July 16, 2024

Sound Transit c/o South County Transit Partners  
401 South Jackson Street  
Seattle, Washington 98104-2826

Subject: Remedial Investigation Work Plan – Addendum No. 1  
Y Pay Mor Cleaners Site  
Federal Way, Washington  
VCP Number: NW3265  
File No. 4082-039-03

<b>Site Plan</b>	
Y Pay Mor Site Federal Way, Washington	
<b>GEOENGINEERS</b>	<b>Figure 2</b>

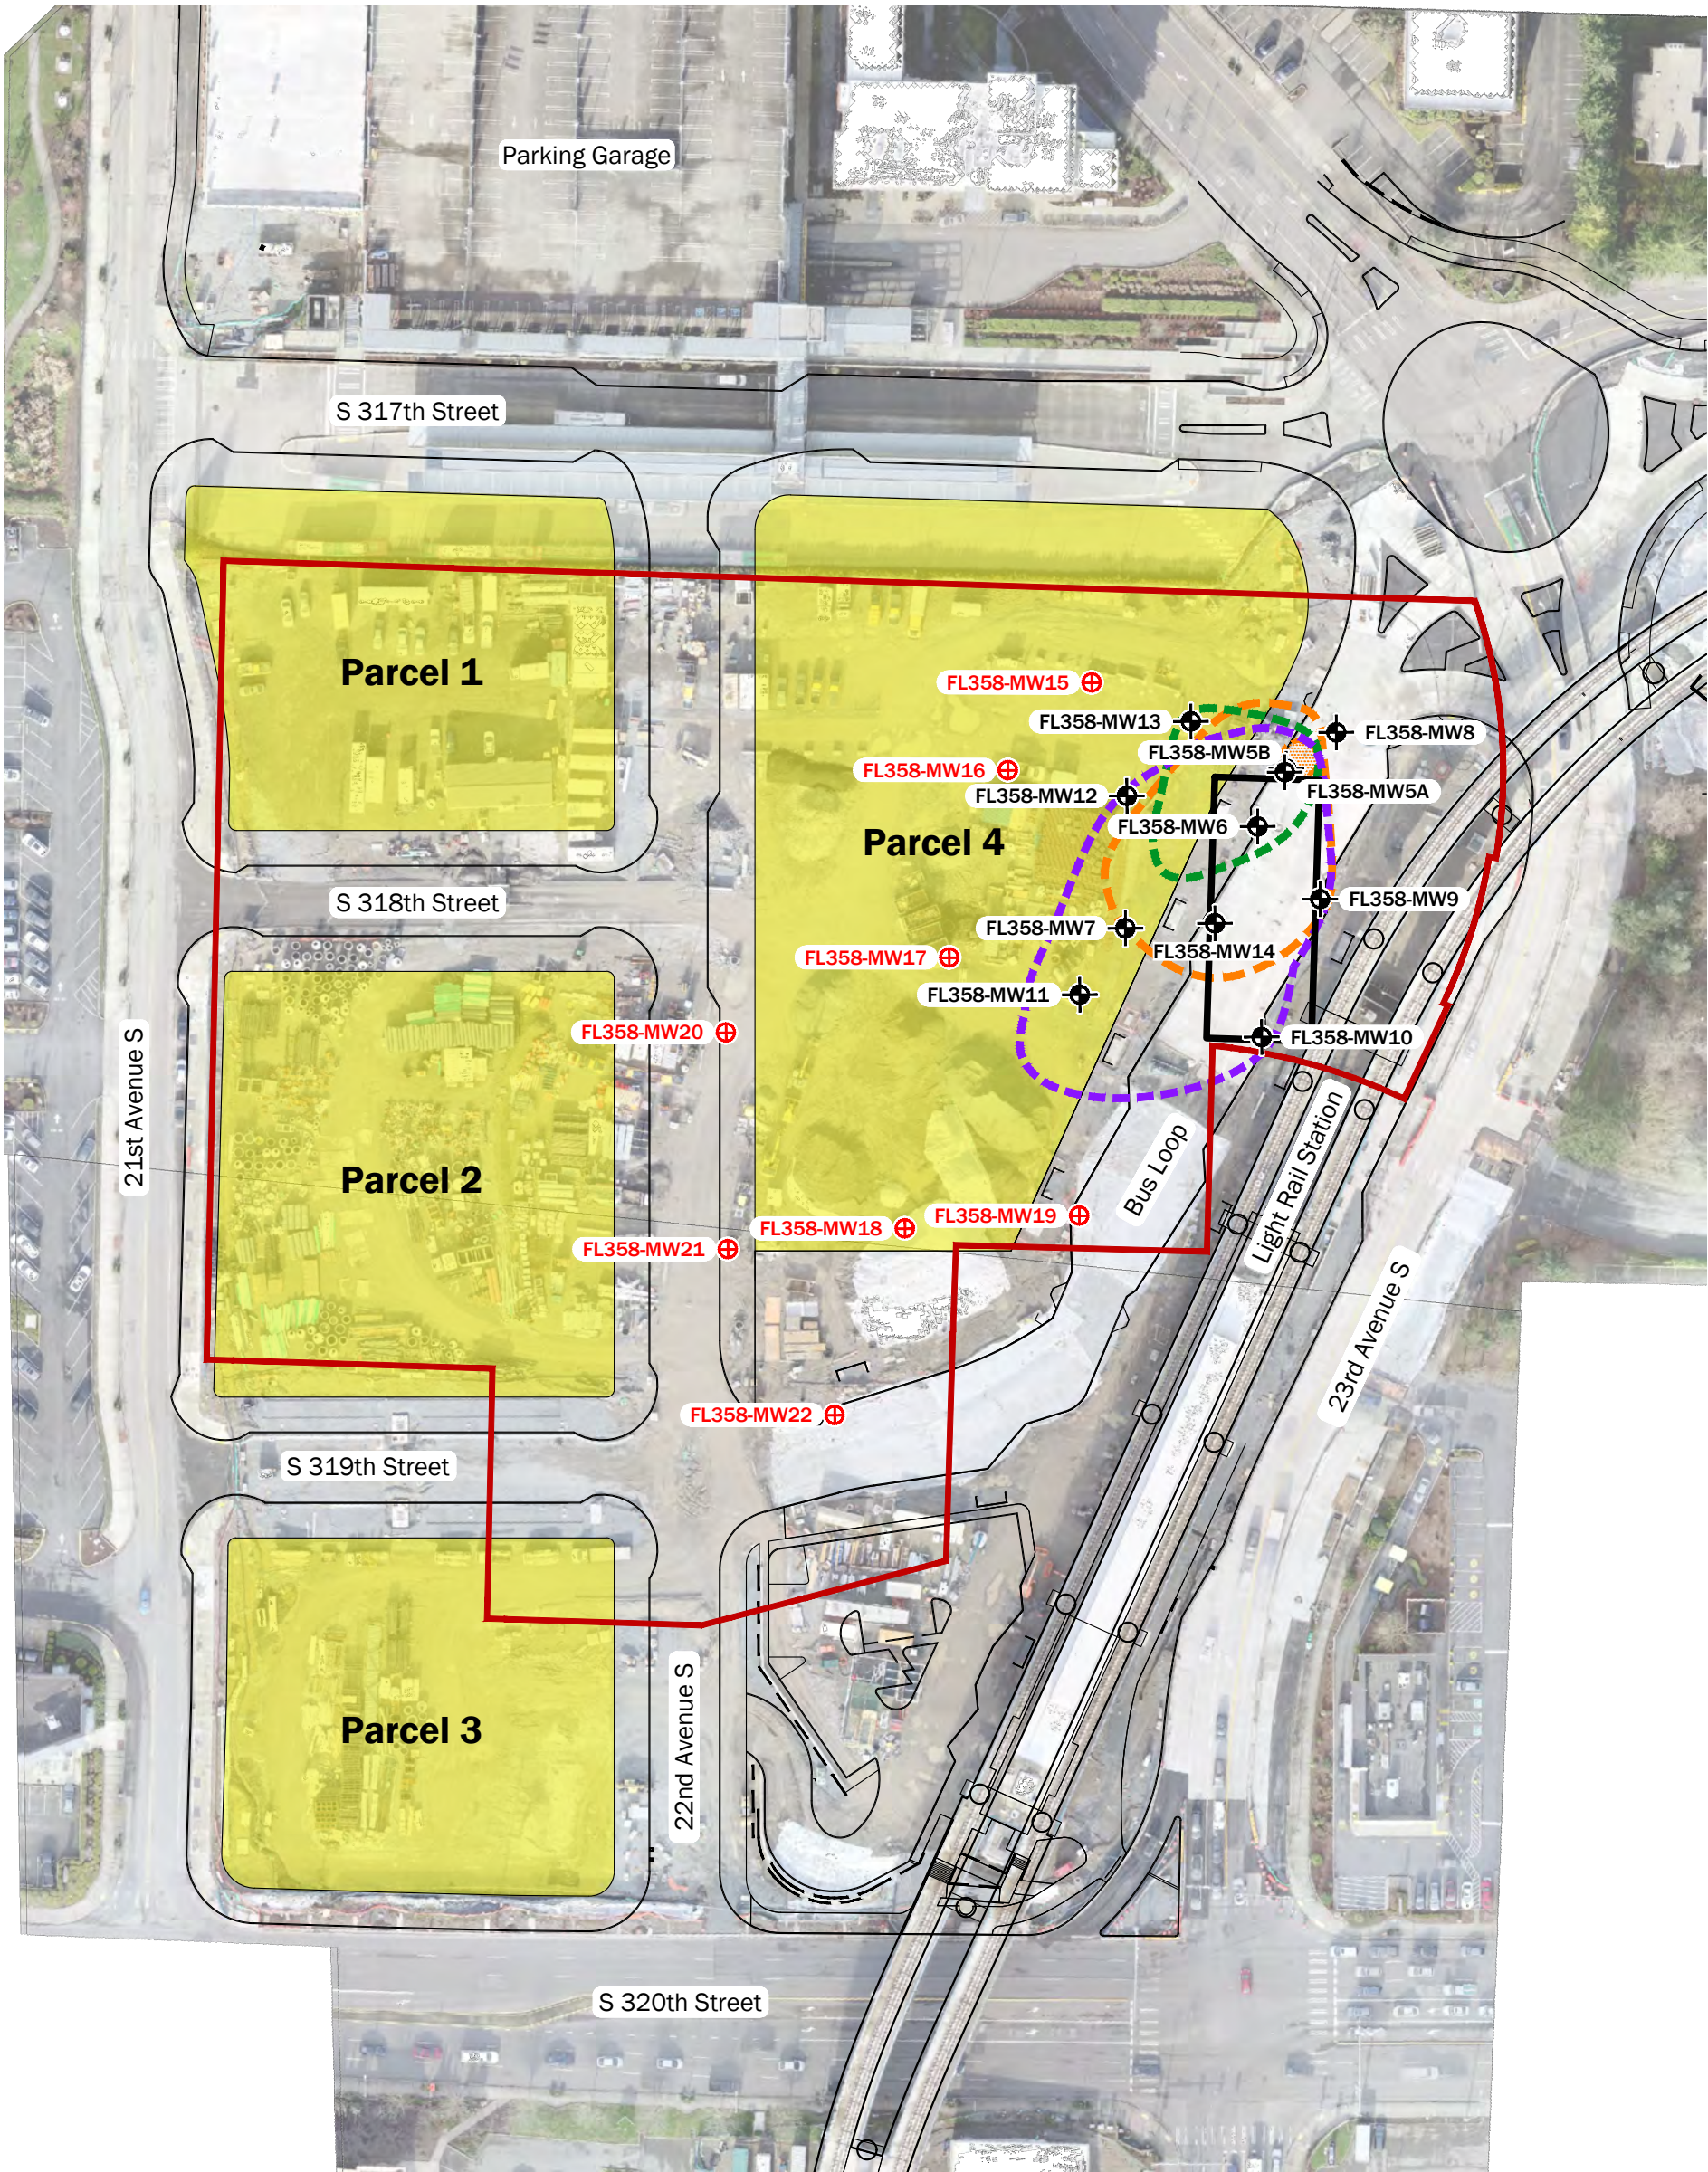
A total of eight new permanent monitoring wells (FL358-MW15 to FL358-MW22) will be installed west, northwest and southwest of the Y Pay Mor groundwater contaminant plume. The proposed wells, the purpose of each well, and the planned exploration boring soil sample analyses are presented in Tables 1 and 2. The locations of the proposed new wells are shown on Figures 2 and 3. Each boring will be extended to a depth corresponding to the top of the confining silt layer. The wells are planned to be installed with the bottom of the well screen positioned at the top of the confining silt layer.
